International Aero Engines SERVICE BULLETIN

CONVERSION SERVICE BULLETIN - ENGINE – CONVERSION OF V2500 D528AQ04 TO
D528AQ03 MODEL

V2500-ENG-72-CN-01

Schematic view of part of harness Loom D - Left hand installation
Figure 1

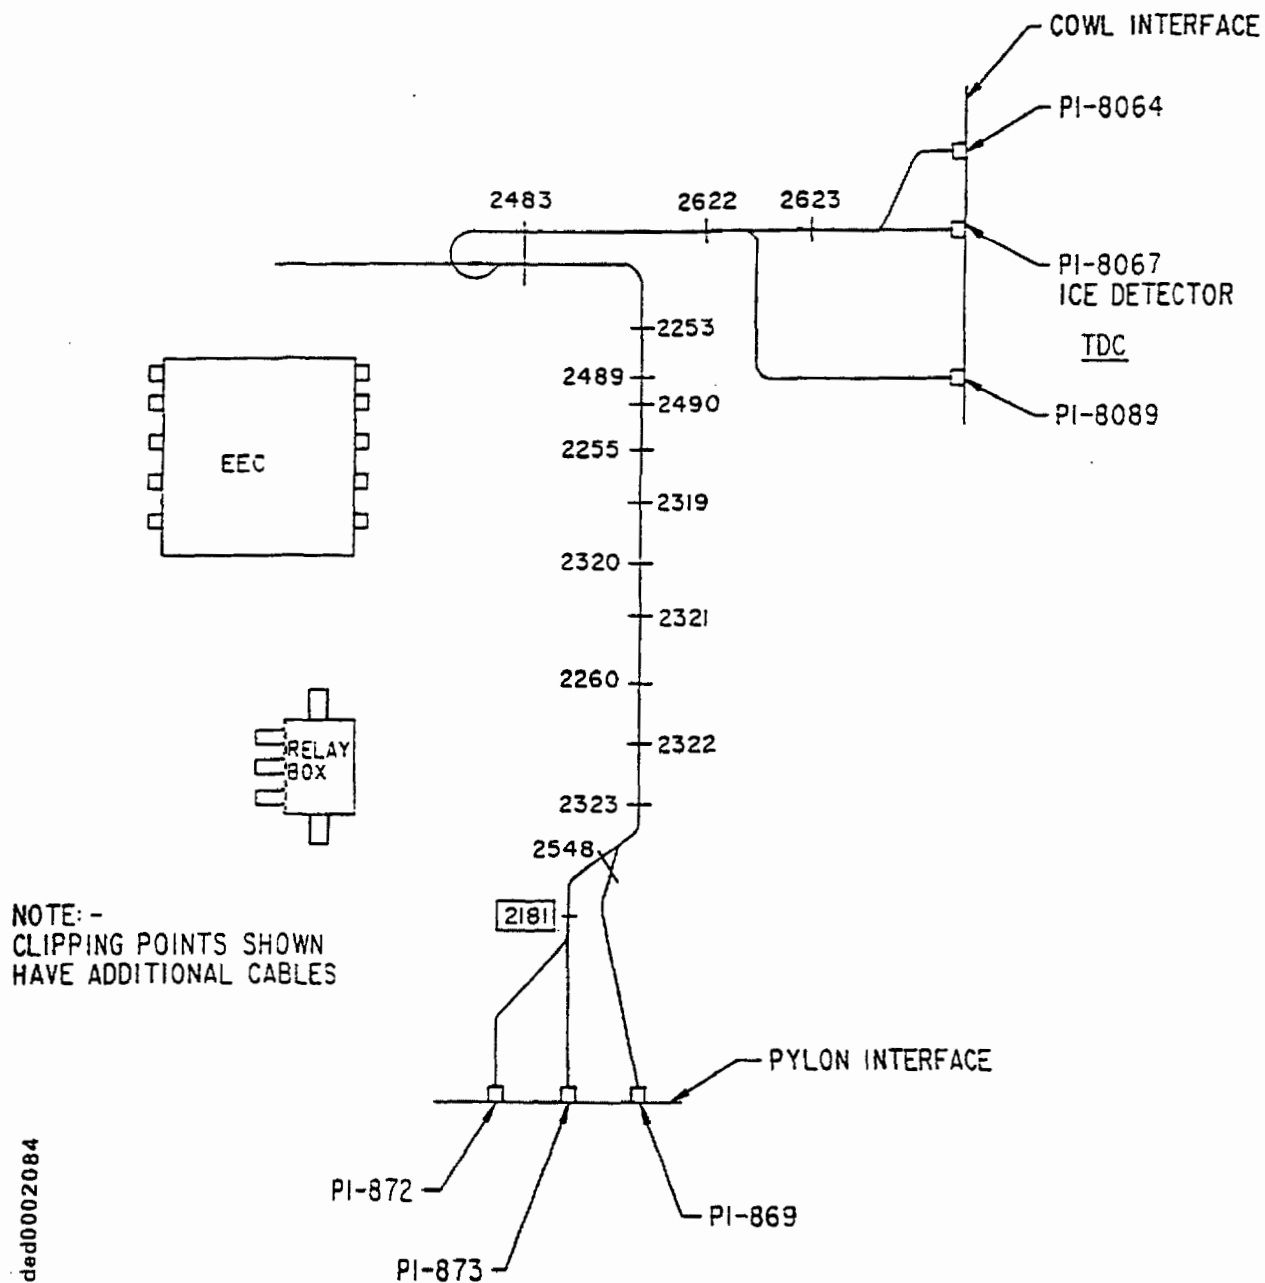
V2500 D528AQ04 model is identical to V2500 D528AQ03 except that it includes additional electrical wiring to support an ice detection system. This wiring is part of the General Services Harness (Loom D) on the fan case. To convert from V2500 D528AQ04 to V2500 D528AQ03 it will be necessary to remove the plugs and wiring which are specific to the ice detection system.

Loom D (part number 6A6541) must be modified to remove the redundant parts. This is accomplished by removing those parts introduced by Service Bulletin 71-0187. The modified harness is re-identified as part number 6A5821. It will also be necessary to modify the affected clipping points. Figures 1 and 2 are schematics of the portion of harness to be modified.

- (1) Locate plug PI-8067 (close to top dead centre at the cowl interface).
- (2) Plug PI-8067 and all cables that run to it are to be removed, as described below.

- (3) At all positions where the cables are tied to the parent harness:
 - i. Remove the cable tie. Take care not to damage the cables.
 - ii. Separate the cables that are being removed from the parent harness.

- iii. Tie the remaining harness bundle (refer to SPP TASK 70-43-02-400-501, SUBTASK 70-43-02-400-015).
- (4) At all positions where the cables are clipped:

- i. Remove the P-clip.
 - ii. Refer to Section 2. Material Information of this Service Bulletin for details of changes (if any) to the bolt and P-clip at this clip point. If necessary, replace the bolt and/ or P-clip.

- iii. Re-assemble the clip point with the remaining harness bundle (refer to SPP TASK 70-43-02-400-501, SUBTASK 70-43-02-400-004).
- (5) The cables being removed terminate at the pylon interface connectors PI-869 and PI-873. It is necessary to remove the relevant cables and pins from these connectors, and insert blanks. Two (2) cables terminate at connector PI-869. Four (4) cables terminate at connector PI-873.
